**October 15, 2004  
ADDENDUM NO. 1**

**PLANS, CONTRACT DOCUMENTS, AND TECHNICAL SPECIFICATIONS  
DATED October 2004**

**MAIN STREET EXTENSION PROJECT**

Valve Extension Details

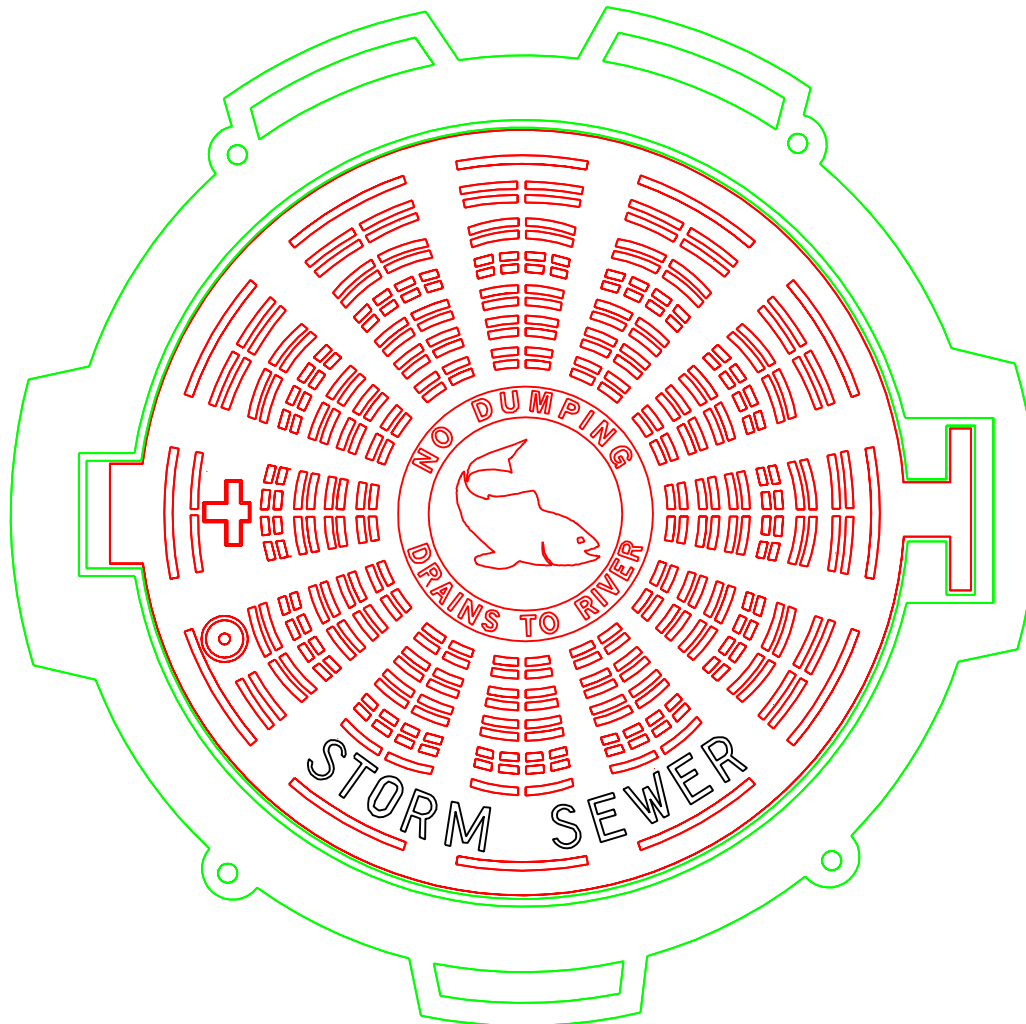
6. Sheet C62, Valve Extension Detail is missing from plans and is attached to this Addendum.
7. Sheet C76, the note on this sheet about Rexel Ductile Iron Ring and Covers with the Bass emblem does not apply to inlet boxes, it only applies to storm drainage junction boxes like the ones found on Sheet C78. See detail attached to this Addendum.

NOTE: WATER MAINS DEEPER THAN THAT ALLOWED BY THE CITY OF KERRVILLE SPECIFICATIONS WILL REQUIRES SPECIAL WRITTEN PERMISSION FROM THE CITY ENGINEER.
